Subject: Answers to MDDELCC questions and comments – Request for exemption from Chapter II of the Québec Environment Quality Act for mining exploration (stripping and trenching) at James Bay by Les Mines Opinaca Ltée (Your Ref.: 3214-14-042)

Les Mines Opinaca Ltée (MOL) hereby present you with answers to questions and comments issued by the MDDELCC on January 24, 2017, with regards to the request for exemption from Chapter II of the Québec Environment Quality Act for the project mentioned in the subject line.

Carte de localisation des chemins	
Projection: NAD 1983 UTM Zone 18N	Échelle: 1:25,000
Date: 08/03/2017	
Auteur: S. Girardeau	
<small>Raccourci: M:\ArcGIS\Travaux en cours\Campagne de forage surface 2017\1 - Carte\ECOFA\Secteur Synee - itinéraire potentiel.mxd</small>

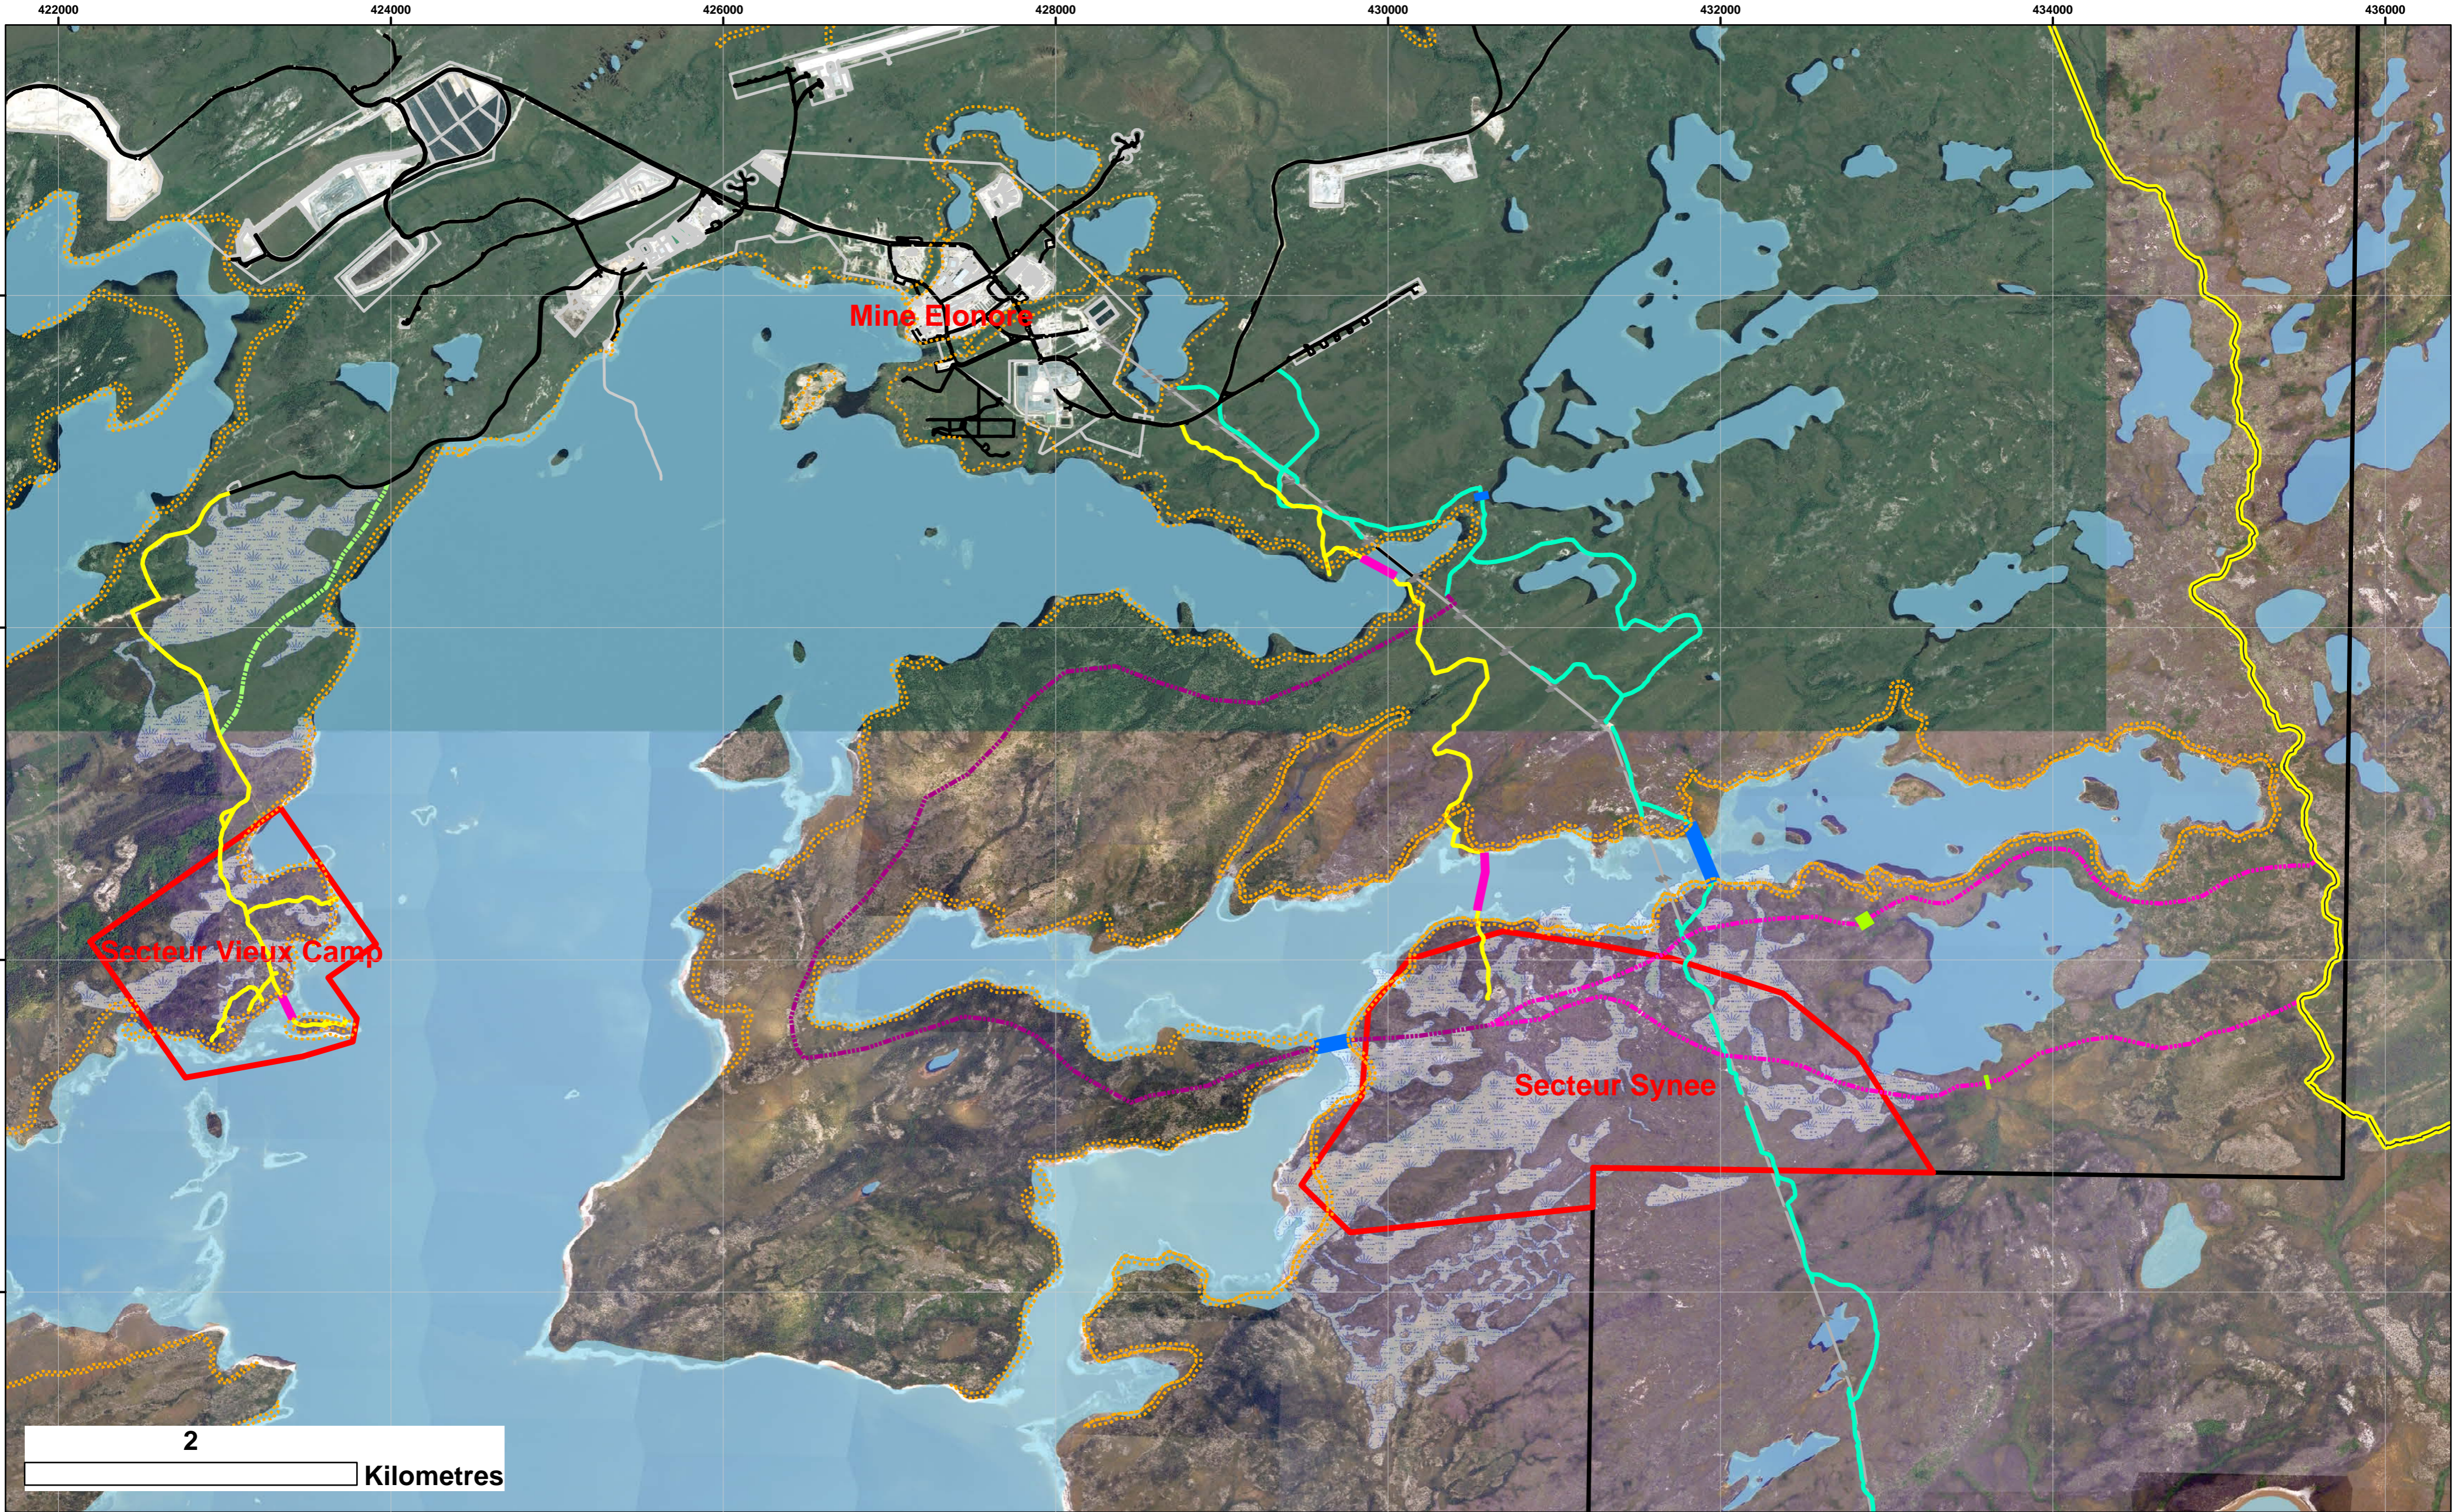
***QC-1:** The developer must define the actual area which will be affected by their exploration project, including possible destruction of wetland areas. They must propose mitigation measures in such an event. They must also provide details and maps of roads to be built, including water crossings as the case may be, as well as describe related potential impacts.*

Access roads to both sectors of exploration will remain the same for now and as identified on maps supplied along with the request for exemption. Note that they have been located in such a manner as to minimize infringement on wetlands, water habitats and waterways. The routes that have been elaborated also minimize tree cutting and promote the use of existing roads. New roads could be built based on exploration phase evolution and results yielded. Any new road will be built in compliance with the “*Règlement sur les normes d’intervention dans les forêts du domaine de l’État (RNI)*”. The attached map indicates the location of winter roads currently in use and the location of existing and potential roads under evaluation for summer use. The main impacts associated with the implementation of roads have previously been discussed in section 5 of the original request.

No waterways or water bodies will be crossed in the Vieux Camp sector, with the exception of drill sites 10, 65, 66 and 82 located on a peninsula. The latter can be reached by building an ice bridge in winter or by barge or helicopter in summer.

Other than the two crossings of the Opinaca Reservoir planned this winter, two waterways have, however, been identified in the East sector along the alternate route, which traverses the right-of-way for a Hydro-Quebec transmission line. The eventual building of bridges, bridging or culverts

will be implemented as need be and according to provisions established by the “*Règlement sur les normes d’intervention dans les forêts du domaine de l’État (RNI)*”. Considering the importance of determining the best possible access route for the East sector and eventual drilling/stripping sites, a hydrological study of the East sector and a planning and design study of water crossing works may be required. Required requests for authorization will be made to relevant government bodies based on routes decided upon and on the scope of the works to be undertaken.
